PUR-1751  
ADDENDUM NO. 4  
INVITATION TO BID

HAGERSTOWN REGIONAL AIRPORT  
EXPAND/REHABILITATE TERMINAL BUILDING EAST

**DATE: Friday, June 20, 2025**

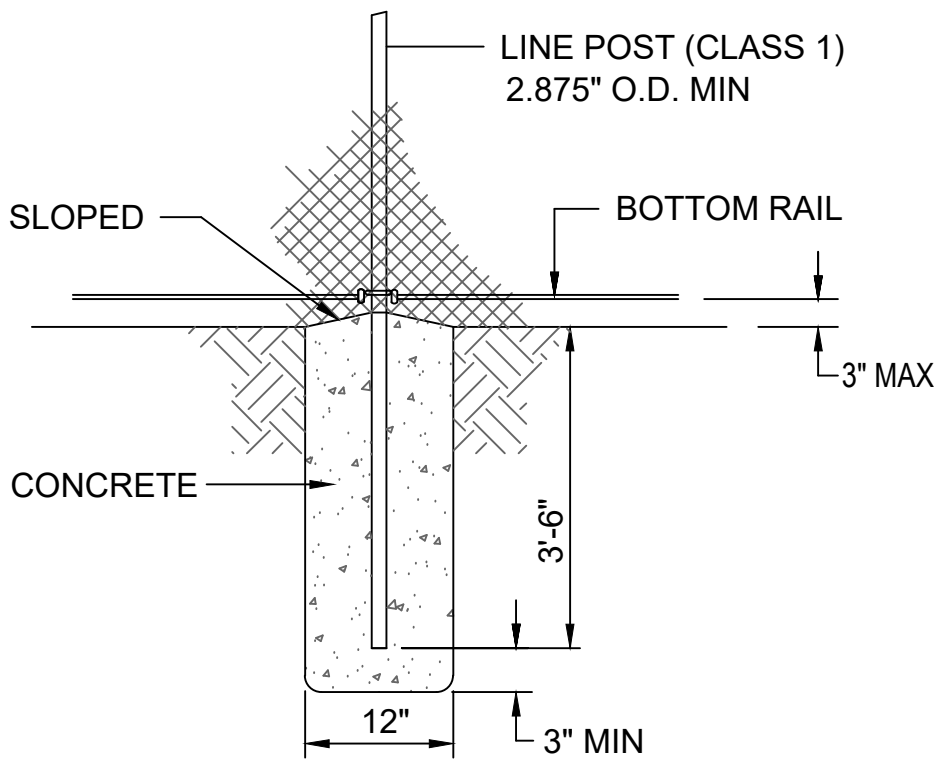
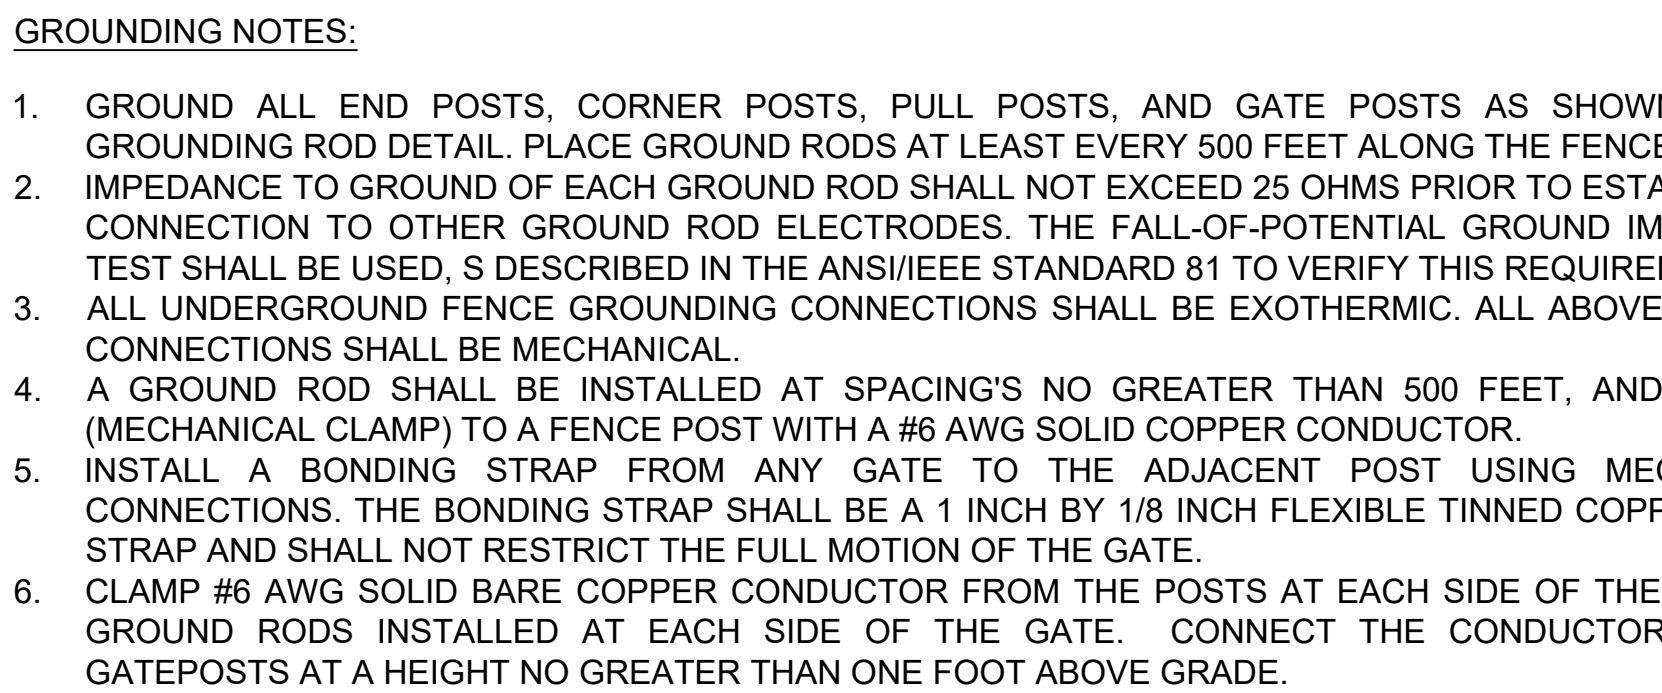
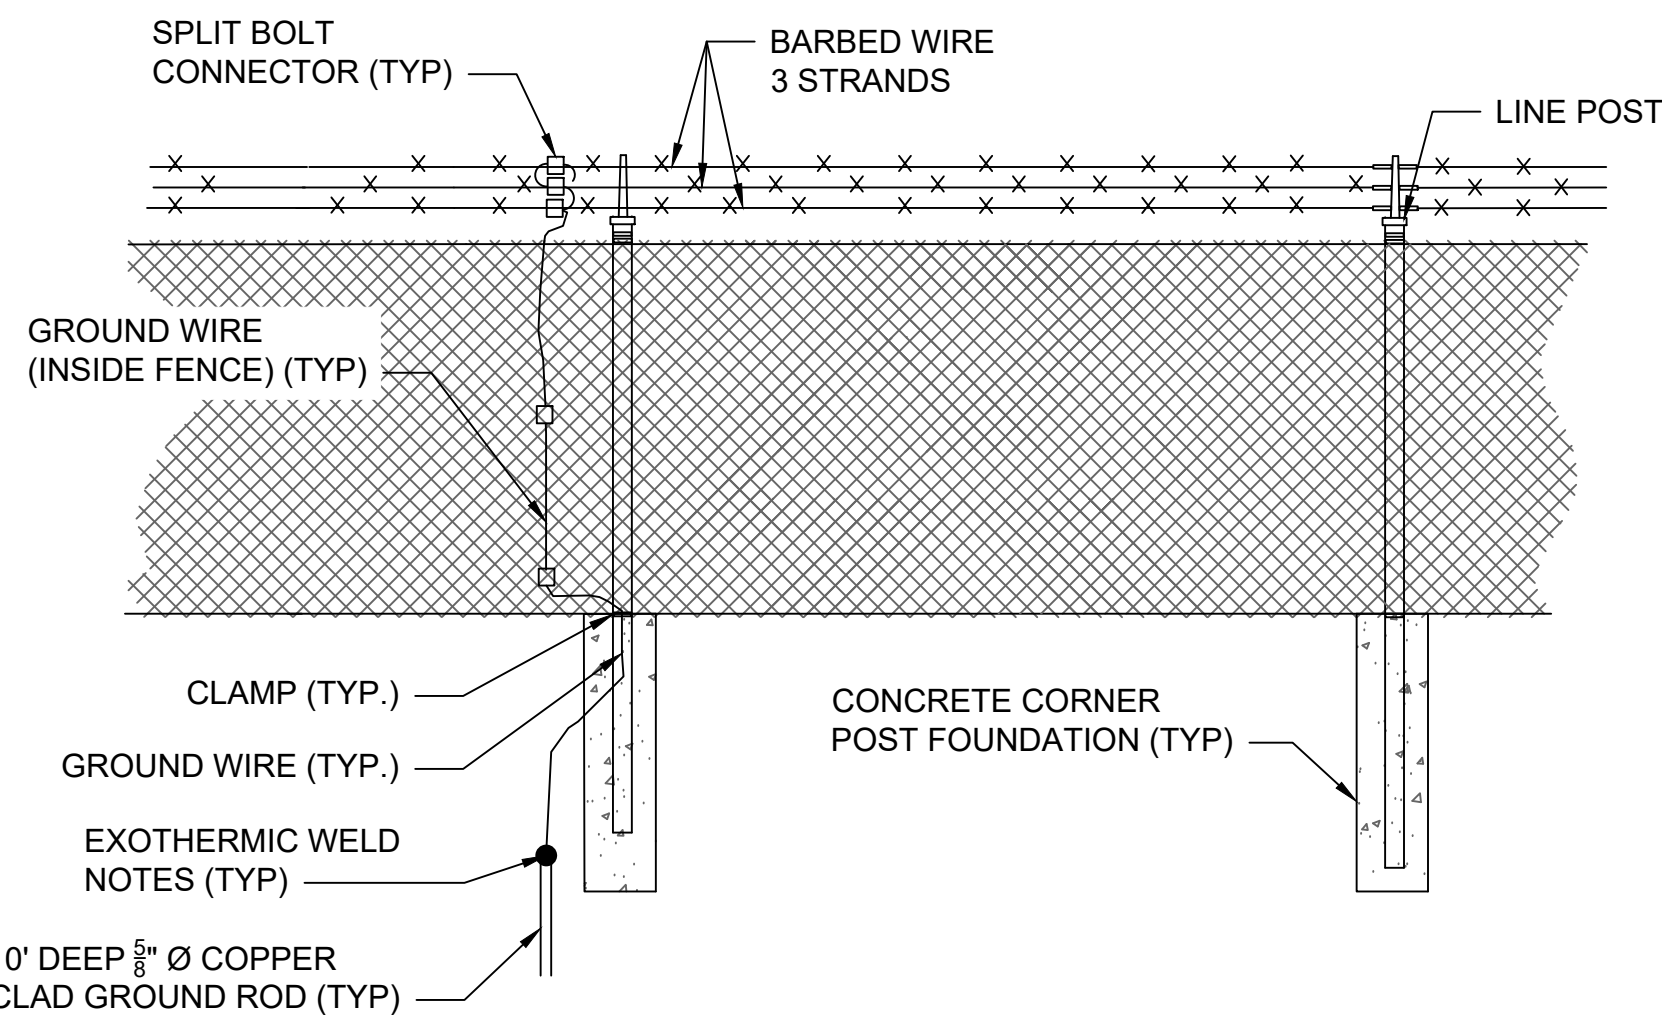
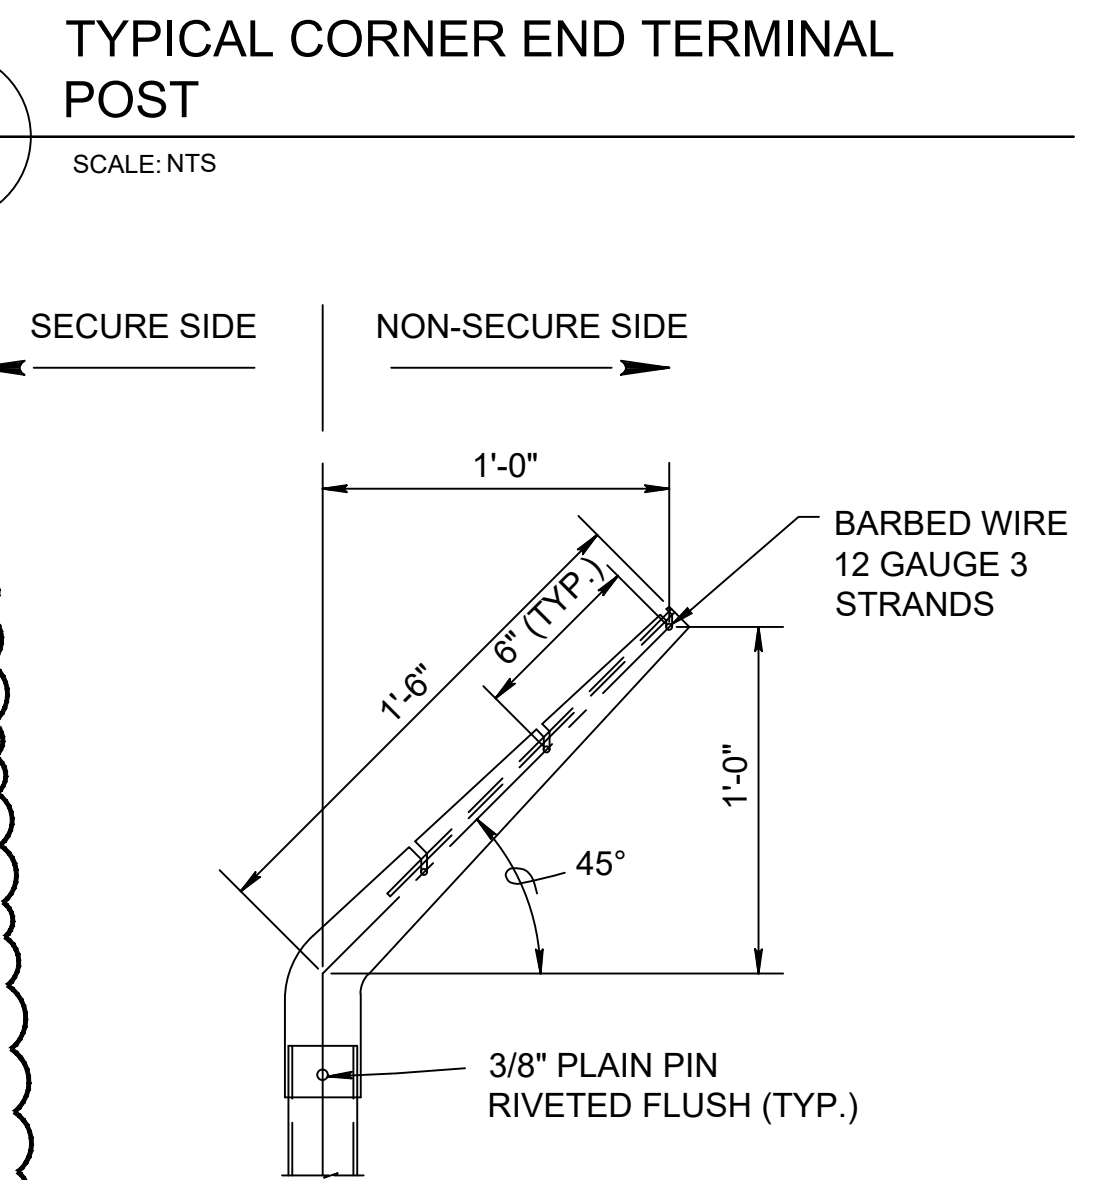
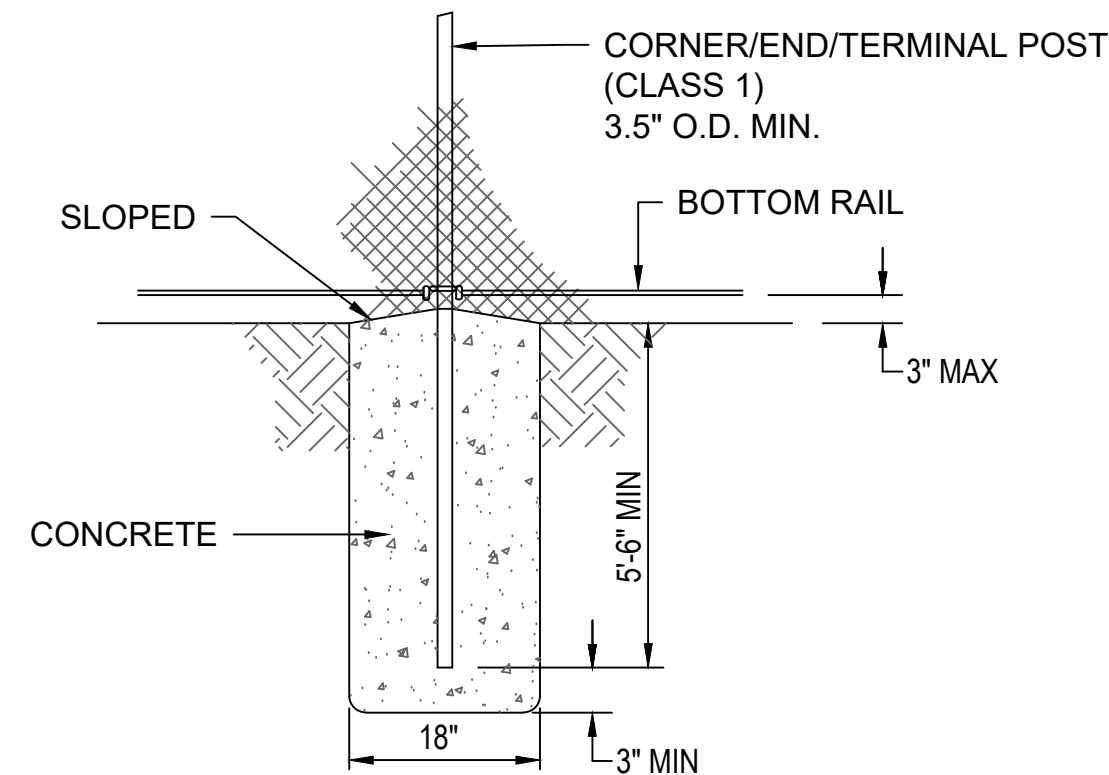
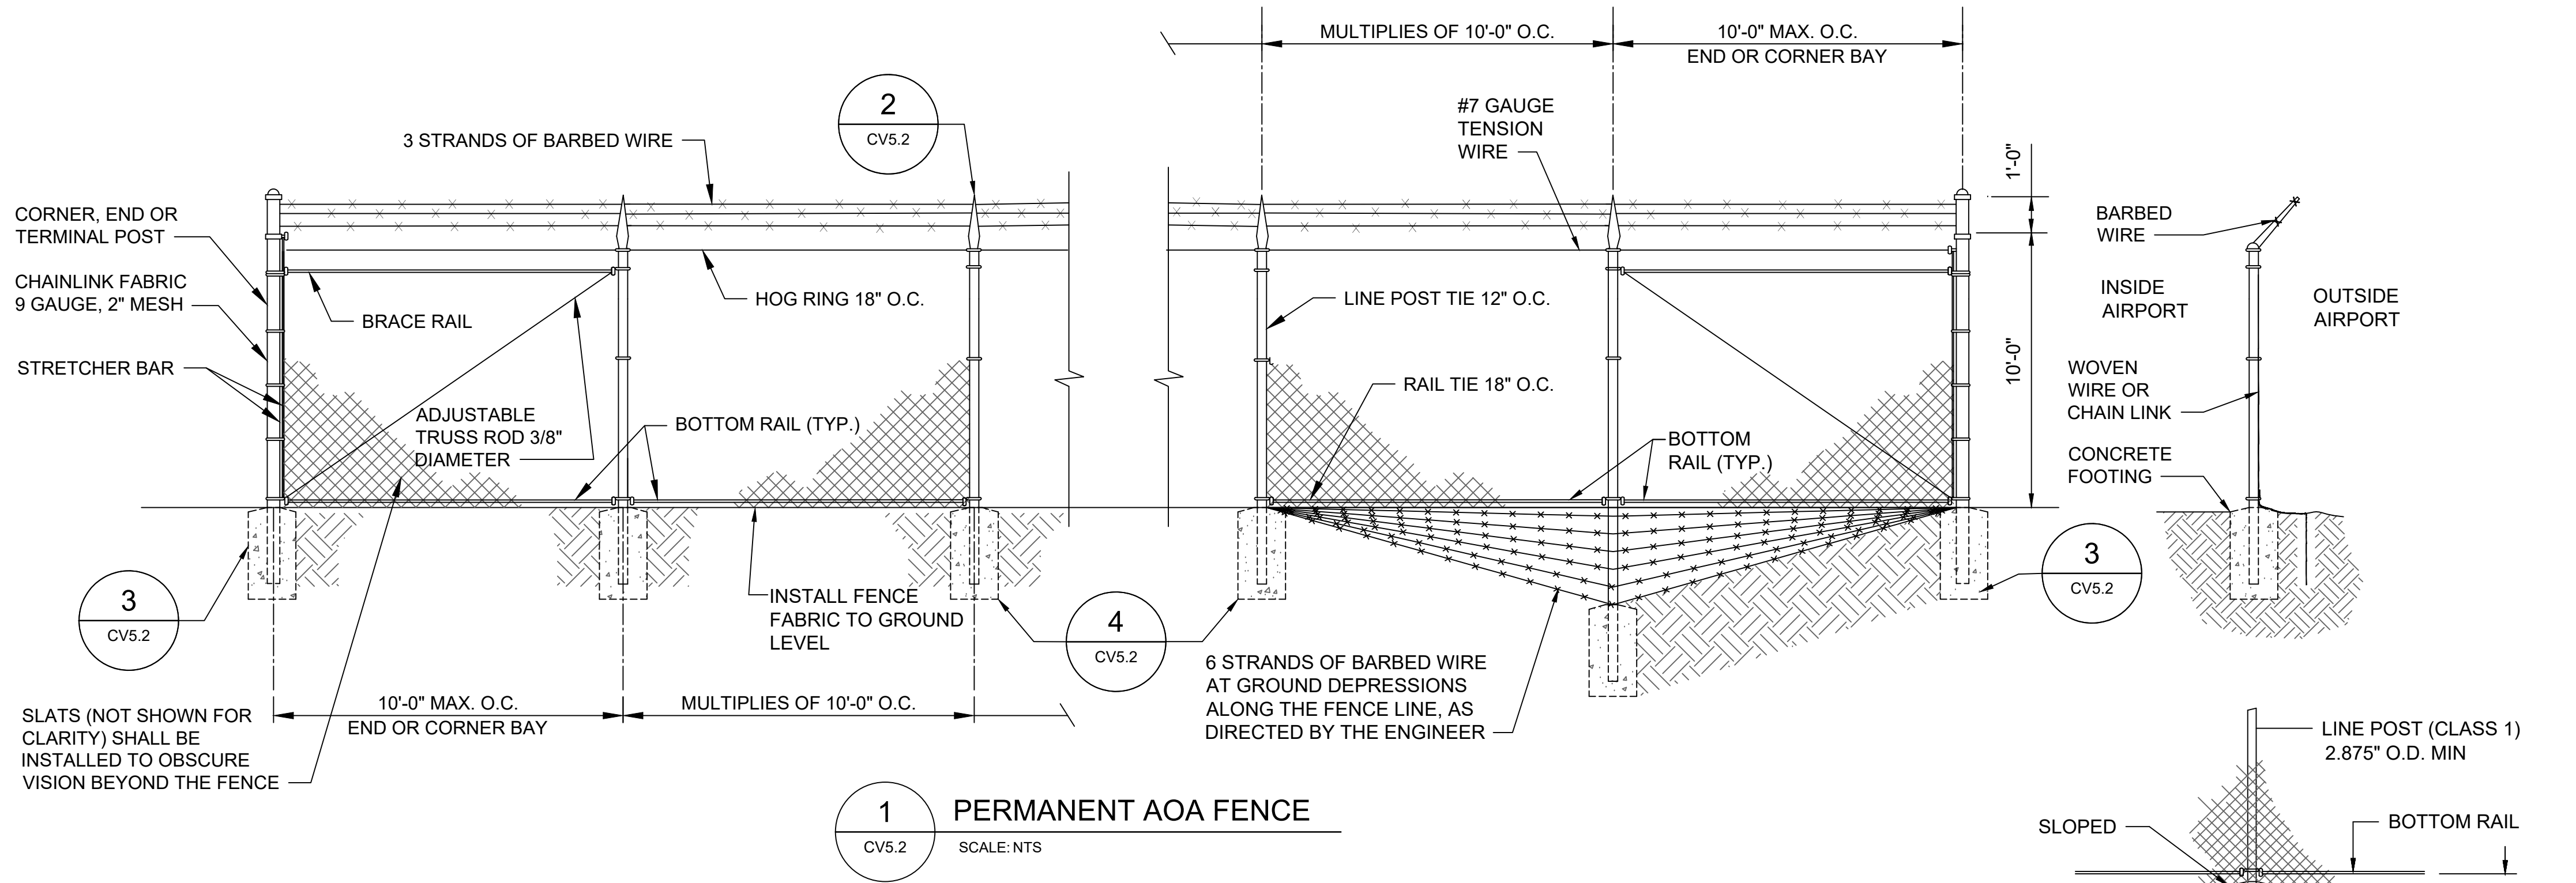
**ITEM NO. 32:** *Inquiry:* Will a drawing detail be provided on the duct bank?

*Response:* An underground conduit trench detail has been added to Sheet No. CV5.2 Site Details 2. REPLACE Sheet No. CV5.2 Site Details 2 with one attached to this Addendum. (Attachment A)
